Engineering Change Notification

Technical adjustments of wall brackets & module connectors

ECN No
239635

Project Title
Technical adjustments
of wall brackets &
module connectors

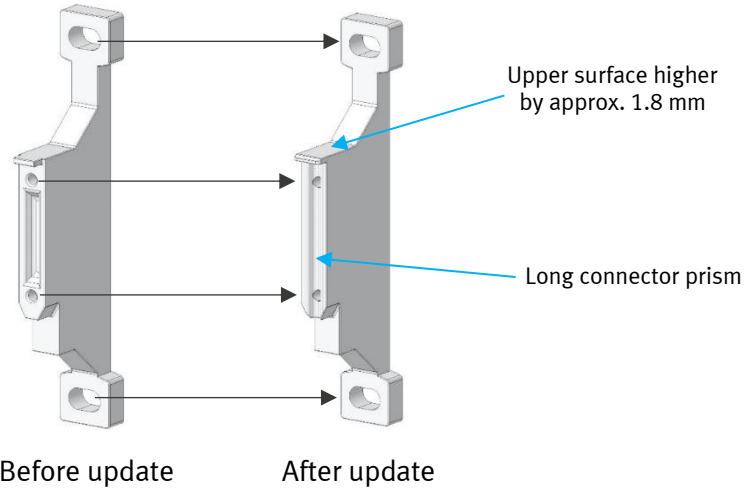
Front module*: Slightly different dimensions and new screw head.

MS4 (before update)	MS4 (after update)
Dimension module connector: 8 x 41,8 x 8,7 mm	Dimension module connector: 8 x 43,2 x 8,7 mm
Screw length: 38,3 mm	Screw length: 42,7 mm
Screw head: Kombi-TORX 10	Screw head: Hexagon socket 2

MS6 (before update)	MS6 (after update)
Dimension module connector: 10 x 61,9 x 10,6 mm	Dimension module connector: 9,8 x 63,15 x 11,3 mm
Screw length: 58,3 mm	Screw length: 62,7 mm
Screw head: Kombi-TORX 20	Screw head: Hexagon socket 2.5
